UNION ELECTRIC COMPANY

ULNRC-835

DOCKET NUMBER 50-483
CALLAWAY PLANT, UNIT 1
CALLAWAY TECHNICAL SPECIFICATIONS

Attachment: Specifications Changed Since Reference 2

FIGURE 2.1-1
 REACTOR CORE SAFETY LIMIT - FOUR LOOPS IN OPERATION

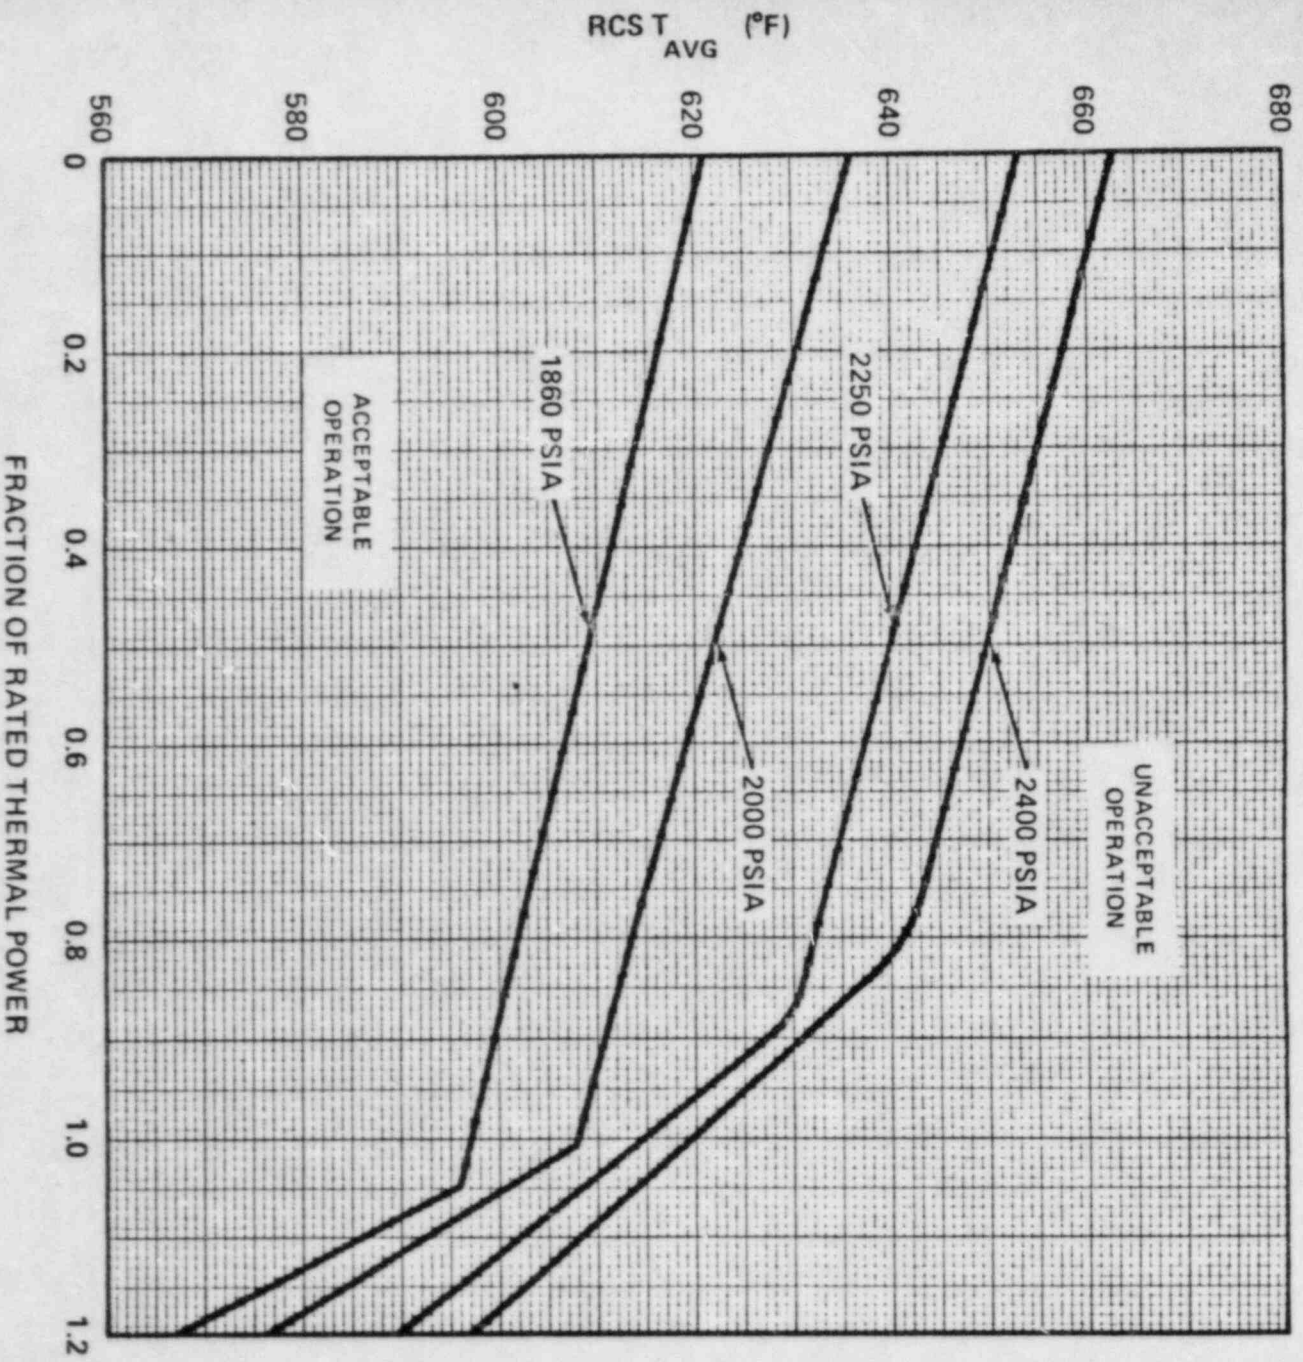
Item	Page *	Agree	Open	Issue
1	2-2	X		Typo
2	3/4 2-15	X		"Actual" versus "Indicated"
3	3/4 3-49	X		Remote Shutdown Instrumentation
4	3/4 3-50	X		Remote Shutdown Instrumentation
5	3/4 3-51	X		Remote Shutdown Instrumentation
6	3/4 3-56	X		Typo
7	3/4 3-68	X		Typo
8	3/4 4-2	X		RCP Special Test Exception and Typo
9	3/4 6-15	X		Containment Cooling
10	3/4 6-26	X		Typo
11	3/4 7-13	X		Ultimate Heat Sink
12	3/4 8-9	X		Battery Float Voltage
13	3/4 8-10	X		Battery Float Voltage
14	3/4 8-12	X		Deletion of an Action Statement
15	3/4 8-16	X		Containment Penetration Conductor
16	3/4 8-34	X		Typo
17	3/4 8-35	X		Typo
18	3/4 8-43	X		Typo
19	3/4 9-7	X		Refueling Spec.
20	3/4 10-4	X		RCP Special Test Exception
21	B3/4 0-1	X		"Actual" versus "Indicated"
22	B3/4 0-2	X		Editorial
23	B3/4 0-3	X		Editorial
24	B3/4 2-6	X		"Actual" versus "Indicated"
25	B3/4 4-2	X		Pressurizer Bases
26	B3/4 4-16	X		Typo
27	B3/4 6-2	X		Structural Integrity
28	6-3	X		Organization Chart
